MANDATORY WING SPAR MODIFICATION FOR AEROBATIC FLIGHT

Document: CHANGE NOTICE #2 TYPE I (CN-2-I)

Model: RV-3, RV-3A

SPAR MOD - CN-2-3 RV-3

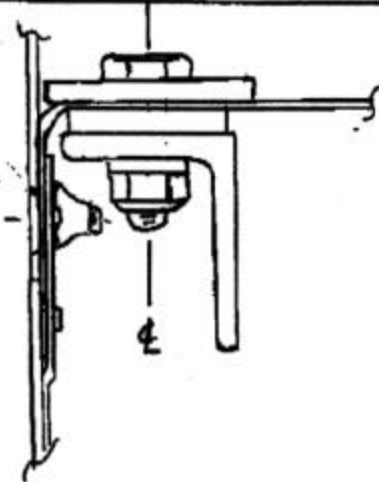
THE PROBLEM !

WITH ANGLE HARD UP AGAINST A NUT FOR TANK :-
 THERE IS NOT ENOUGH ROOM TO FIT NUTS AND
 SCREWS FOR TANK.

WHEN FITTING SPAR MOD CN-2-3 TO
 MY RV-3 I FOUND I HAVE THIS PROBLEM. IF
 I TURN THE ANGLE THE FIX WORKS. (ST 22 AND OTB ONLY).

DO YOU THINK THAT IT WILL STILL WORK IF I USE THIS
 FIX? THE TWO ANGLES 1B OF ST 22 WILL HAVE TO BE
 MADE TO WORK (SOME HOW!). WHAT ELSE CAN I DO IF YOU
 DONT THINK I SHOULD? (NEW WING?)

The 1/8 x 1 x 1 1/4 angles act as stiffeners to the spar bars. These angles help to strengthen the structure by helping it resist buckling due to compression loads primarily in the upper spar cap bars. Generally, the greatest amount of compression would be in the outermost part of the spar bar. That is why the flange of this additional angle was situated as close to the outer part of the bars as it was. According to my figures, there should have been enough room for the platenuts provided the wing was built according to our specifications. With that, we offer another possible solution.

In an effort to keep the horizontal flange of the angle as close to where it was located during our static tests (as shown on the CN-2-3 drawings), drill a relief hole (see attachment 1) at the points of interference with the platenuts. This relief hole in the 1/8 x 1 x 1 1/4 angle should be no deeper nor larger in diameter than necessary. This will allow the angle to be moved closed to the spar flange so that a nut may be installed.

The design you suggested would also stiffen the spar. However, since we have not tested the spar in this configuration we cannot tell you how effective this would be. If you don't like our suggestion, yours will probably work, just how well we cannot say.
